# Massachusetts Military Reservation

# Final Engineering Evaluation, Cost Analysis, and Execution Plan for Coonamessett River FS-28 Bog Separation Project

November 1998

# APPENDIX D REGULATORY COMMENTS AND RESPONSES

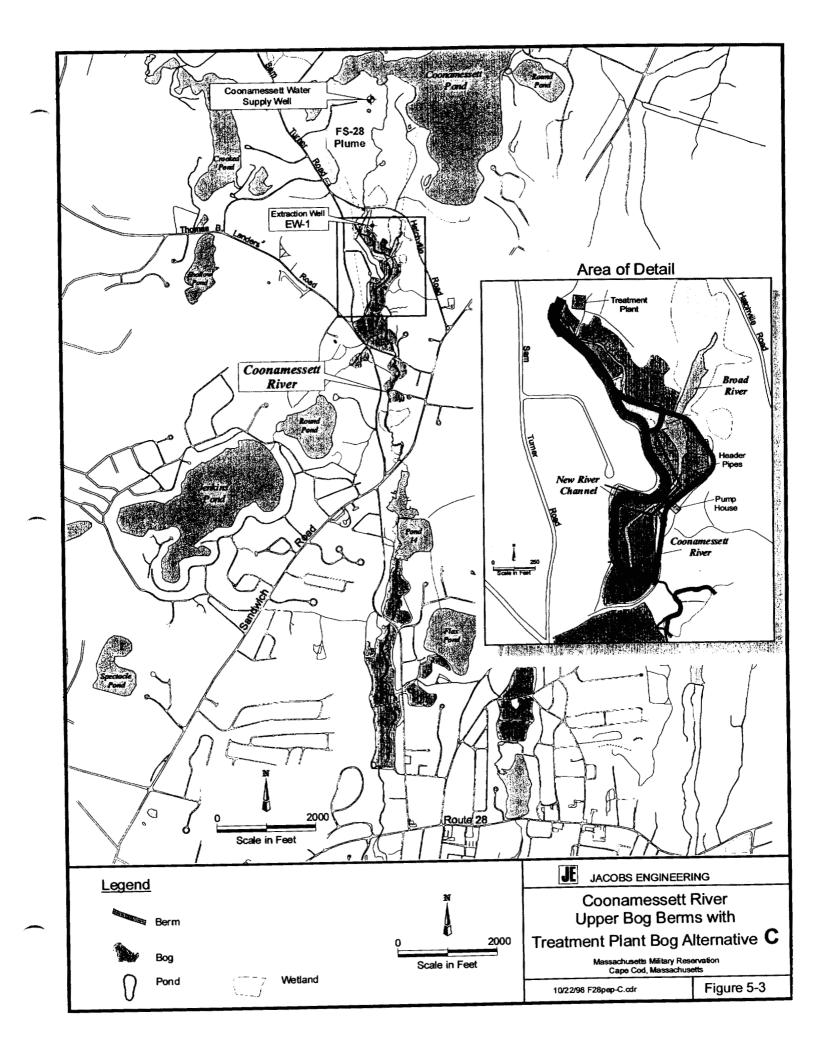
31. Figure 3-1 - Delete Nora Conlon from Federal boxes.

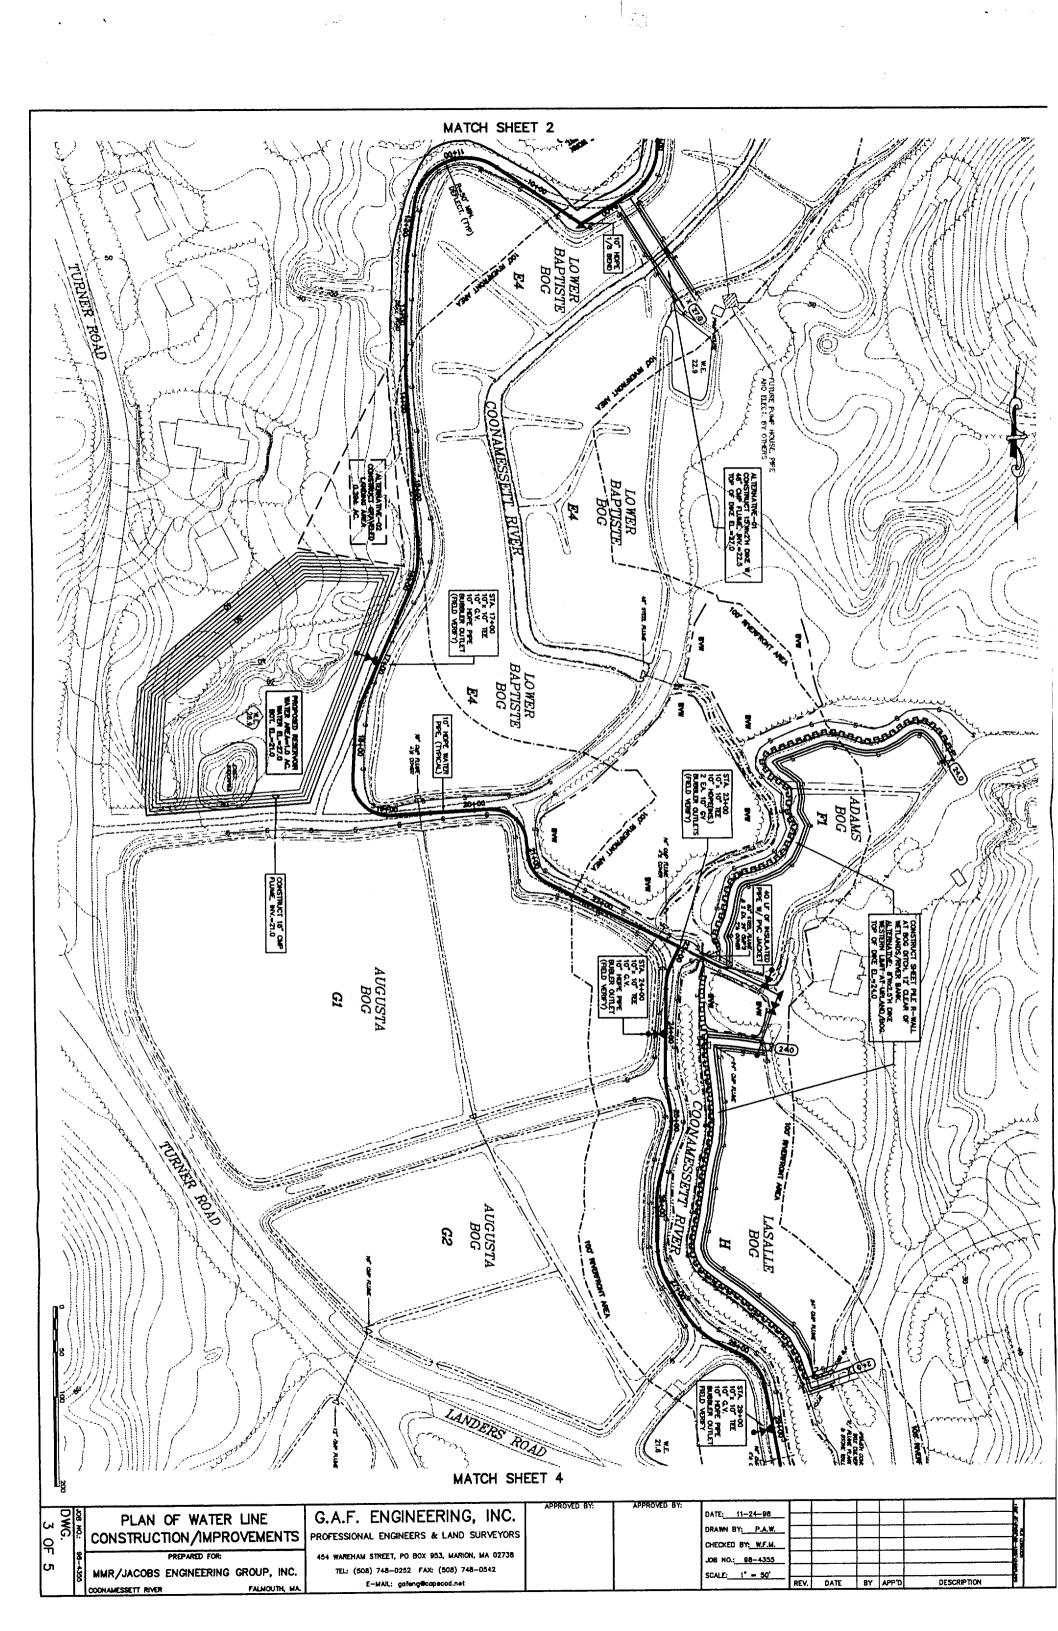
28. Figure 6-1 and Appendix C, Sheet 2. At the bog site visit on November 8, 1998, the AFCEE stated a number of changes to the proposed plans as detailed in these figures including: a location change for the expanded treatment plant and change in the location of well point discharge pipe. Please provide updated figures as Plan Sheets to allow for sufficient review.
